## **MUKILTEO FERRY TERMINAL (PHASE 2) FERRY TERMINAL CONSTRUCTION**

VOLUME 2 OF 8

VOLUME 2 SHEET INDEX

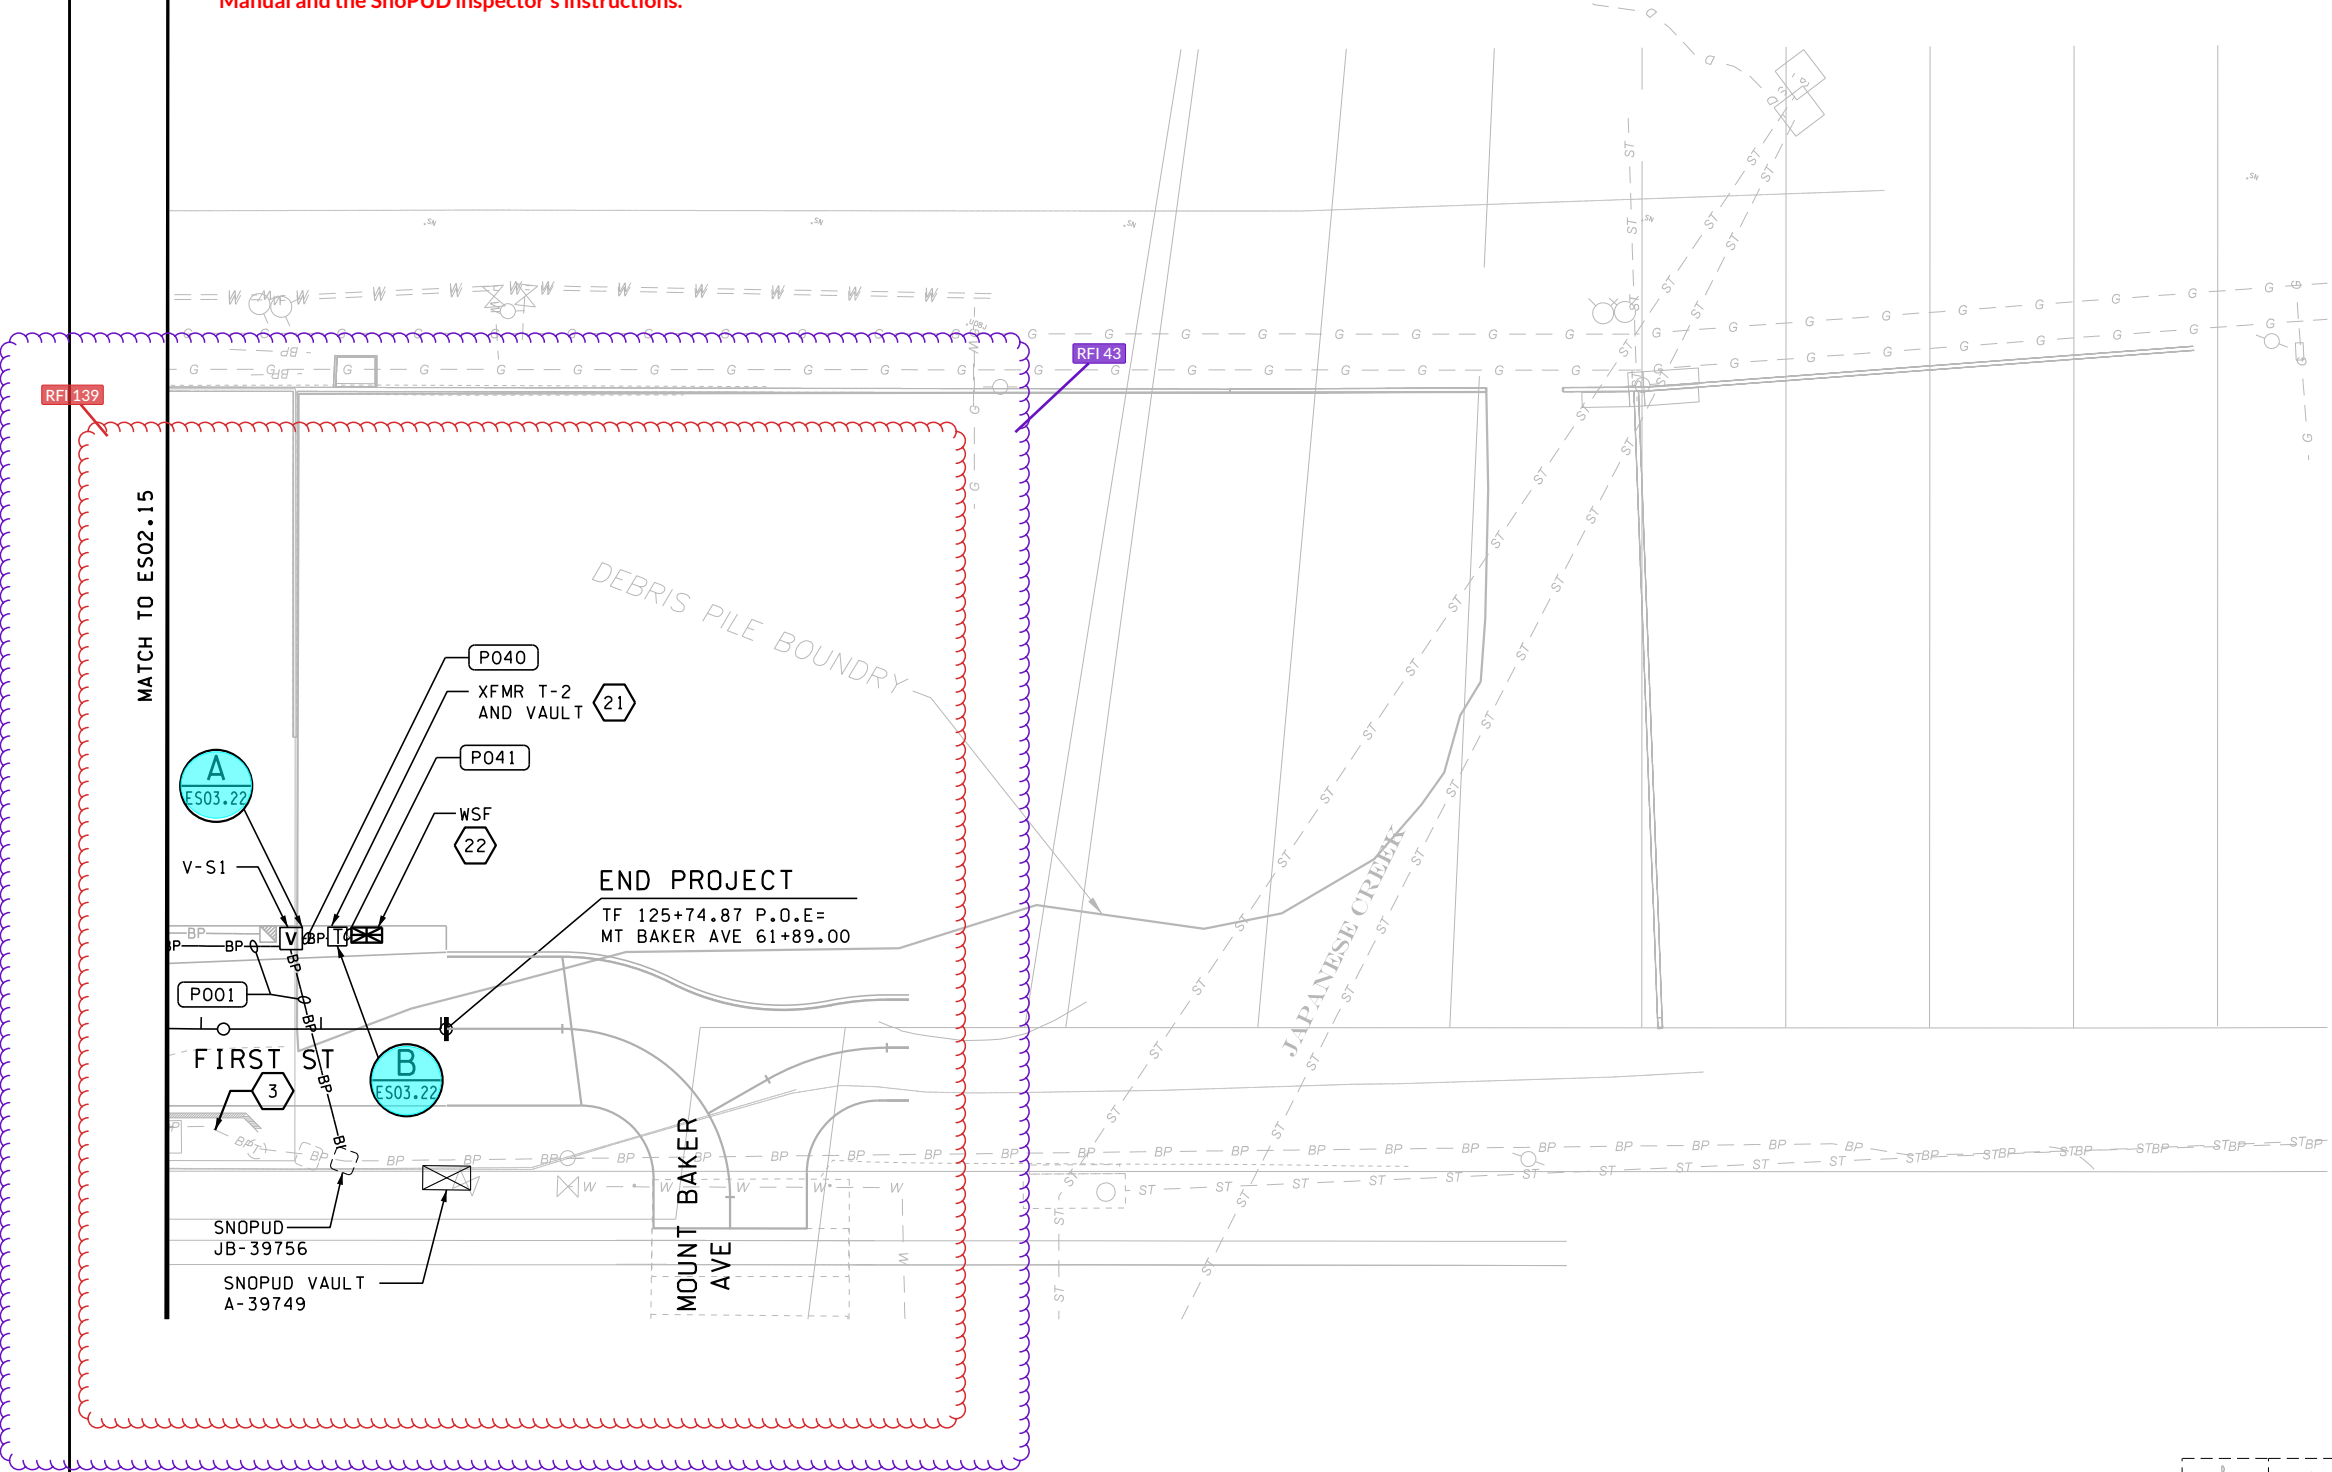
PER RFI 136  
Per spec section 8-20.2(9-29.2(2)A)\_Vaults\_SH.docx "Snohomish County PUD (SnoPUD) vaults shall be per SnoPUD Electrical Service Requirements Manual and coordinated with SnoPUD representative..." Grounding should be installed per the Service Requirements Manual and the SnoPUD inspector's instructions.
